802.3cy link segment insertion loss

May 18th 2021

Thomas Müller (Rosenberger)

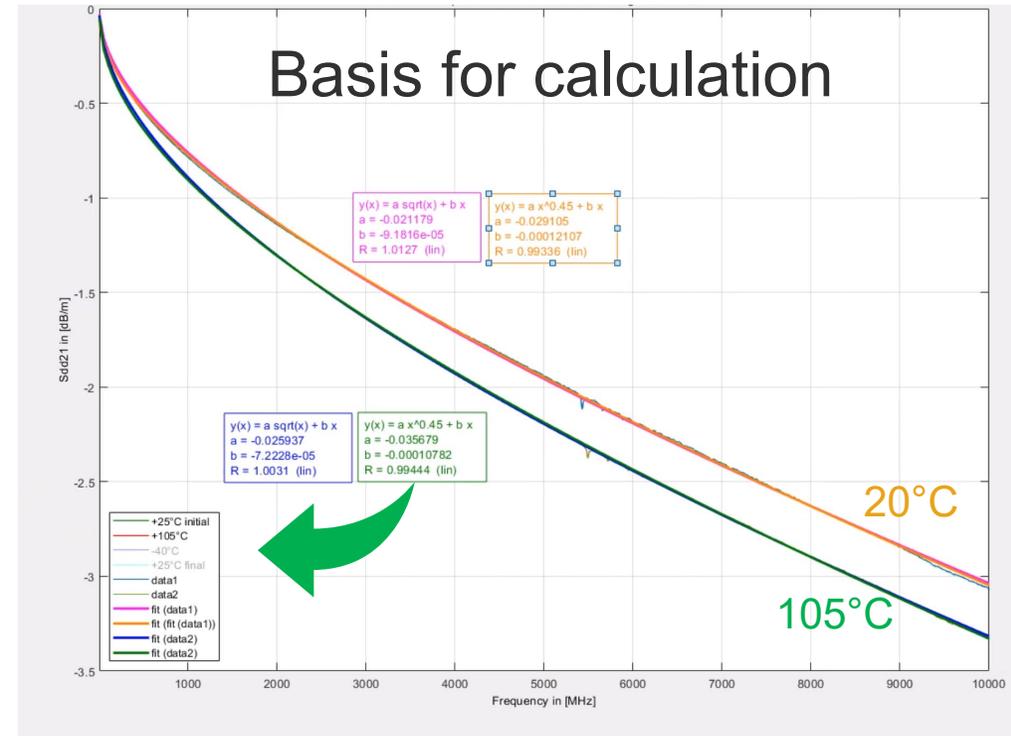
- Summary of results and thoughts in [DiBiaso et al 3cy adhoc 01a 04 20 21.pdf](#) including a suggesting for the link segment IL up to 7 GHz as follows:

- Formula presented by Chris Diminico shows some anomalies at very low frequencies due to the roll-of term included.
- Suggest to improve the formula's slope to better represent the IL variation over temperature, which is currently covered by a constant factor $1.325 \times \left(\frac{6.5}{15}\right)$, while temperature mainly affects resistive loss and add a term for roll-off that follows the proposed slope.
